PROJECT LAYOUT SHEET #63

PROJECT NAME: STOCKBRIDGE-BETHEL
PROJECT NUMBER: STP 2910(1)
FILE NAME: z10b214_bdr_nul_63.dgn
PROJECT LEADER: D.E.G.
DESIGNED BY: L.M.B.
IPARM FILE: z10b214163.i
PLOT DATE: 3/17/2014
DRAWN BY: W.G.P.
CHECKED BY: J.P.S.
SHEET 96 OF 397

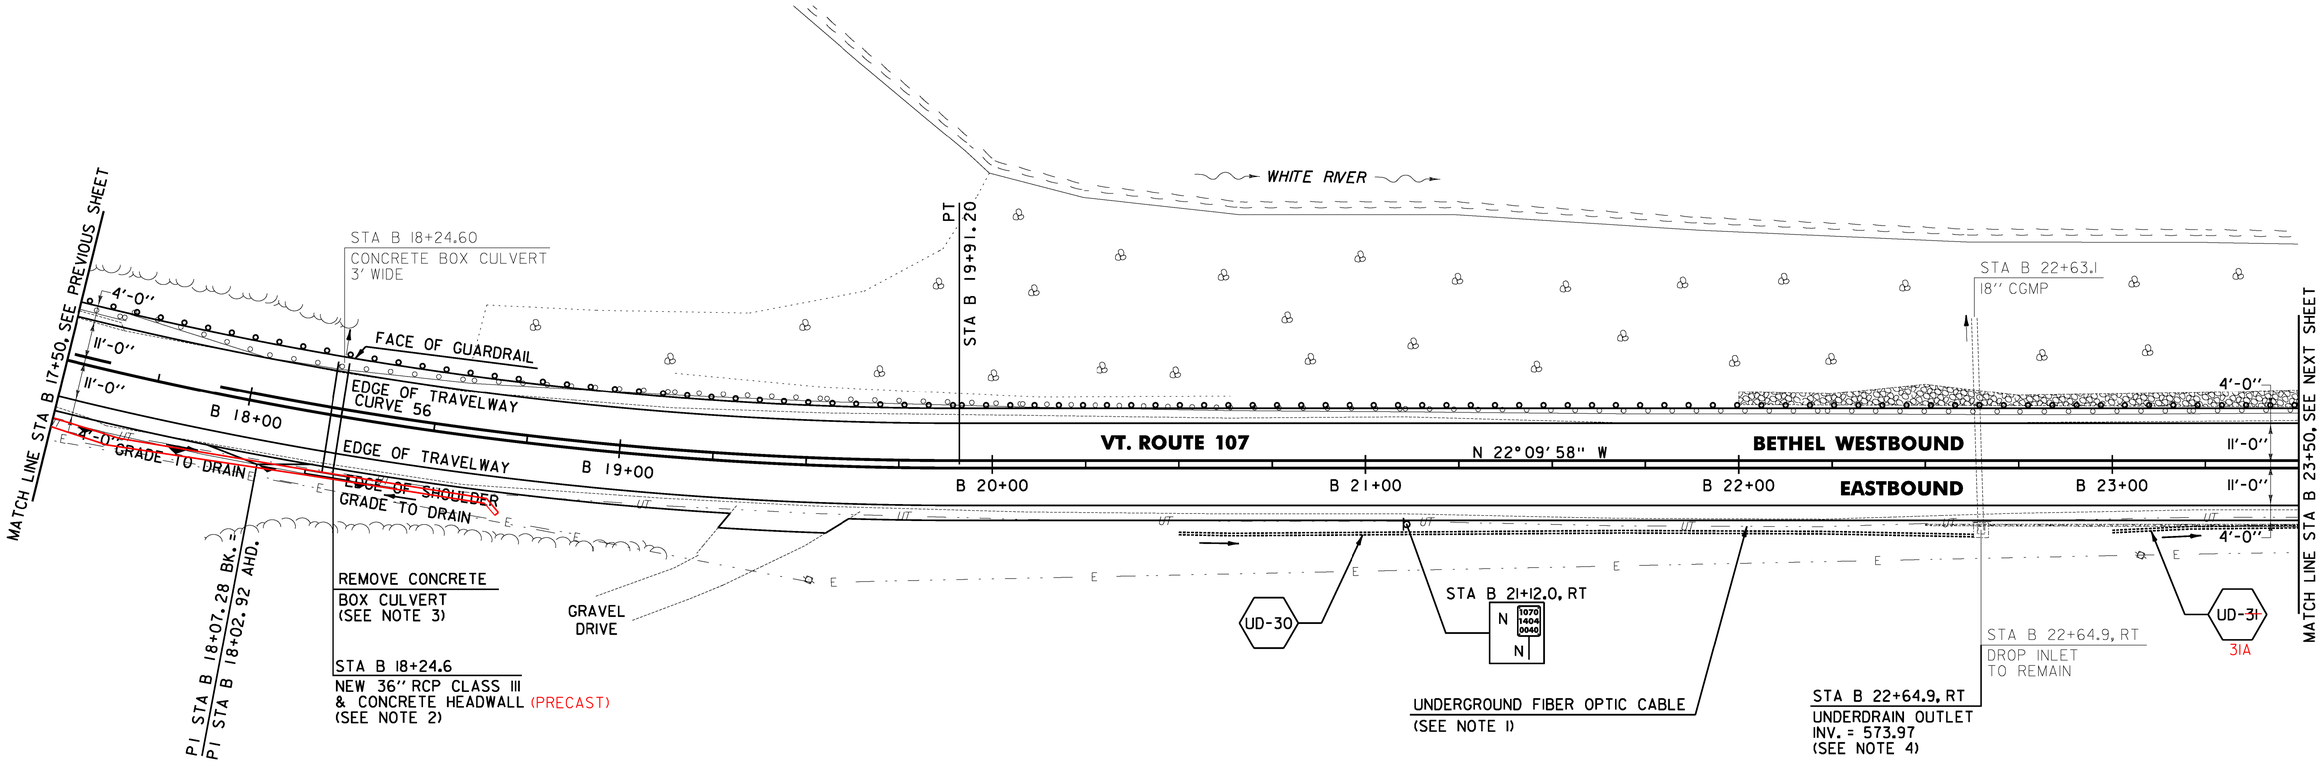
613.10 STONE FILL, TYPE I
BETHEL: STA 18+10.0 - STA 18+34.0 RT
~~STA B 22+00.0 - STA B 23+50.0 LT (32.4 CY)~~
~~STA B 22+50.0 - STA B 23+50.0 RT (2.6 CY)~~
STA 18+18.0 - STA 18+28.0 LT

621.205 STEEL BEAM GUARDRAIL, GALVANIZED W/8 FEET POSTS
BETHEL: 17+68.0
STA B 17+50.0 - STA B ~~17+62.5 LT~~ (12.5 LF)
STA 17+50.0 - STA 18+71.0 LT

621.75 REMOVE AND RESET GUARDRAIL
BETHEL: 17+68.0
STA B ~~17+62.5~~ - STA B 23+50.0 LT (587.5 LF)

~~651.40 GRUBBING MATERIAL (6")~~
~~BETHEL:~~
~~STA B 22+00.0 - STA B 23+50.0 LT (79.7 SY)~~
~~STA B 22+50.0 - STA B 23+50.0 RT (9.1 SY)~~

~~653.20 TEMPORARY EROSION MATTING~~
~~BETHEL:~~
~~STA B 21+00.0 - STA B 23+50.0 LT (129.4 SY)~~
~~STA B 22+50.0 - STA B 23+50.0 RT (9.1 SY)~~
